ADDENDUM No. 2

**Request for Proposal CS-20-03
SUPPLY AND INSTALLATION OF
FIRE OPERATIONS COMMUNICATIONS CENTER WORKSTATIONS**

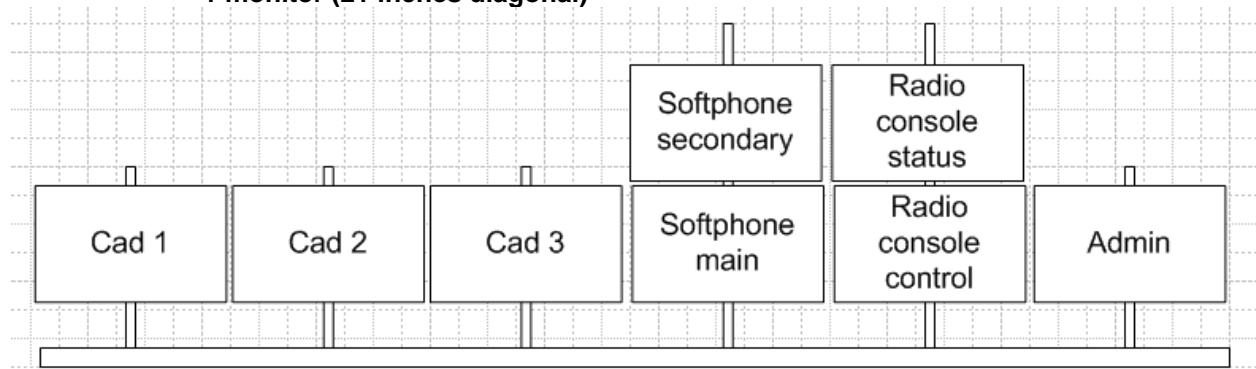
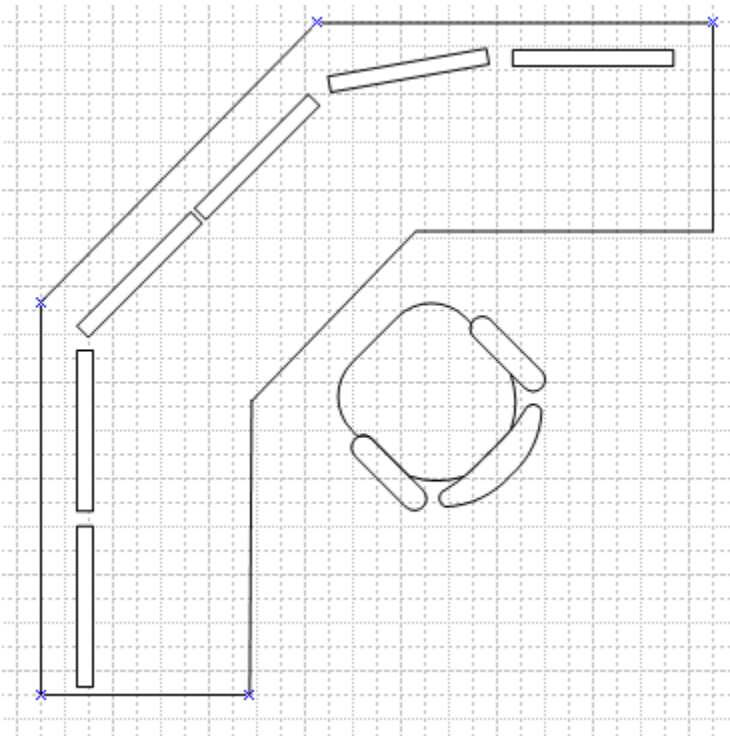
QUESTION 2: Is it possible for you to clarify the number of and sizes of the monitors on each console? There is conflicting information in Appendix C.

ANSWER 2: The dispatch and call handling systems have not yet been purchased so the Regional District is estimating our monitor requirements. For the purpose of this RFP use the following: Looking from the front of the desk starting from the left side

- 3 monitors (21 inches diagonal) individual mounts for each.
- 2 monitors (21 inches diagonal) one above the other
- 2 monitors (21 inches diagonal) one above the other
- 1 monitor (21 inches diagonal)
